Appl. No. 10/625,102
Amdt. dated Oct. __, 2005
Reply to Office Action of July 22, 2005

Amendments to the Drawings:

Appl. No. 10/625,102
 Reply to Office Action of July 22, 2005
 Annotated Sheet Showing Changes

Fig. 3A

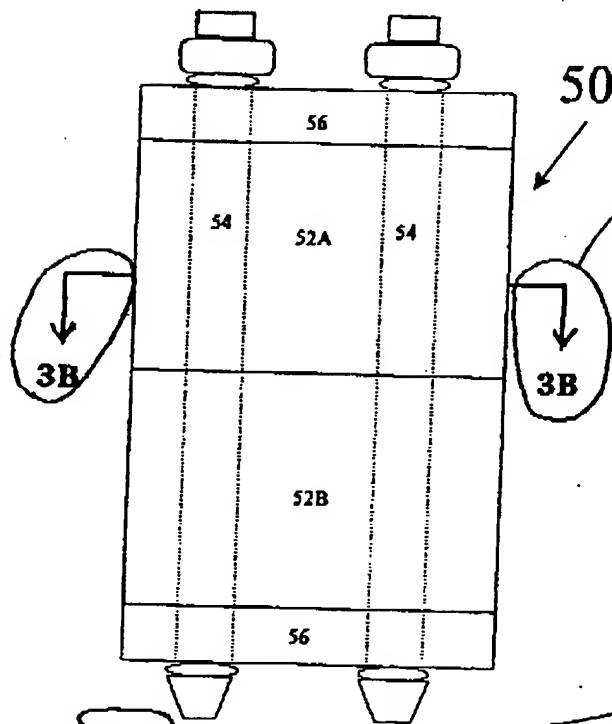
In amended FIG. 3A, the number "244103.F" at the bottom of the figure has been deleted, and appropriate labels and arrows for cross-sectioning line 3B-3B have been added.

In the July 22, 2005 Office Action, the Examiner requires that the number '244103.F' at the bottom of FIG. 3A and FIG. 5A be deleted. In response, Applicant respectfully submits replacement sheets, as well as an annotated marked-up copy showing change, for revised FIGS. 3A and 5A, in which the number '244103.F' at the bottom of these figures has been deleted.

The Examiner also requires that line 3B-3B, line 4B-4B and line 5B-5B be shown in FIGS. 3A, 4A and 5A, respectively, to show where the cross-sections for FIGS. 3B, 4B and 5B are coming from. In response, Applicant respectfully submits replacement sheets, as well as annotated marked-up copy showing change, for revised FIGS. 3A, 4A and 5A showing line 3B-3B, line 4B-4B and line 5B-5B, respectively.

the number "244103.1" deleted

Fig. 6

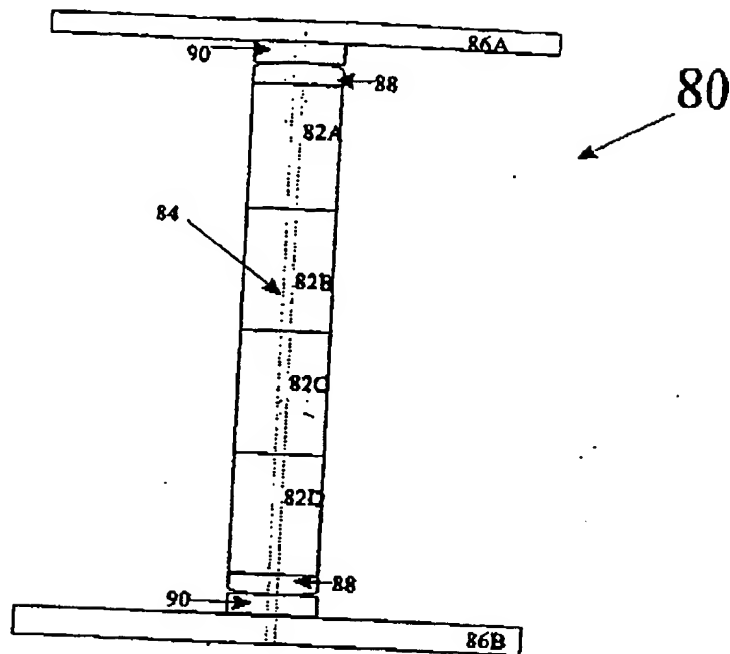
In addition, the Examiner objected to the drawings because reference numeral 88 shown in FIG. 6 does not appear to be described in the specification. In response, the Applicant has amended the paragraph [0057] of the specification to add in the description the reference numeral 88 shown in FIG. 6, which was inadvertently omitted previously. In view of the statement at the end of the paragraph [0057] that "this embodiment can be further modified in accordance with the teachings and principles discussed above with respect to embodiments 10, 10A, 50, 60 and 70," the amendment to this paragraph is supported by element 28 in FIG. 2 and the related text in the paragraph [0047].

Fig. 7

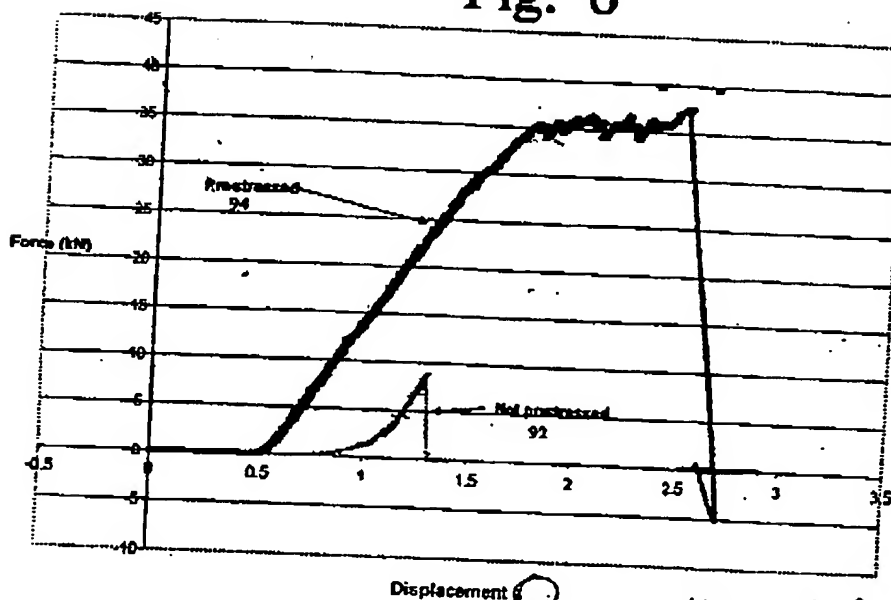
In amended FIG. 7, the unit for displacement in parentheses, (mm), has been deleted. It is respectfully submitted that, while the displacement values in FIG. 7 are indicative of the measure of strain, the numerical values for displacement are provided only for the purpose of comparison between the prestressed and non-prestressed results.

Displacement  the unit for displacement, (mm); deleted
